Xpander

**SOFTWARE REVISION 1.4
Operations Guide**

**XPANDER Software Revision 1.4 - Operations Guide
Part No. 950048**

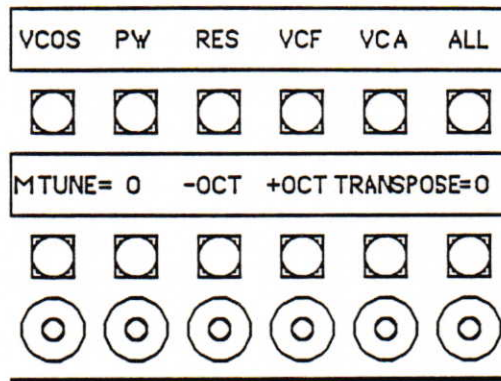
When in the MIDI **SEND** Page, if the destination Patch number is set below 00 (by turning Knob #4 counter-clockwise), the display will read:

SEND ALL PATCHES TO MIDI

DESTINATION PATCH = ALL START

If the button below the display reading **START** is pressed, **all** of the Patches (both SINGLE and MULTI) will be sent out MIDI. This function will take about 17 seconds to complete and the display will read:

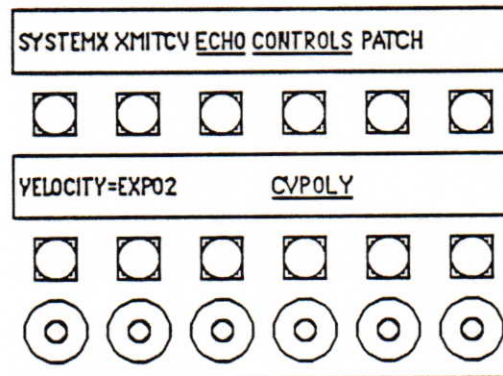
3. The TUNE PAGE functions have been changed slightly in the new version. The displays will now read:

The upper display shows which parameters can be tuned. A fifth tuning has been added – displayed as **VCA** – to allow matching of the final VCA levels of each Voice. The lower display now has two extra functions. The buttons below the **-OCT** and **+OCT** displays can be used to shift the pitch down or up in octave increments.
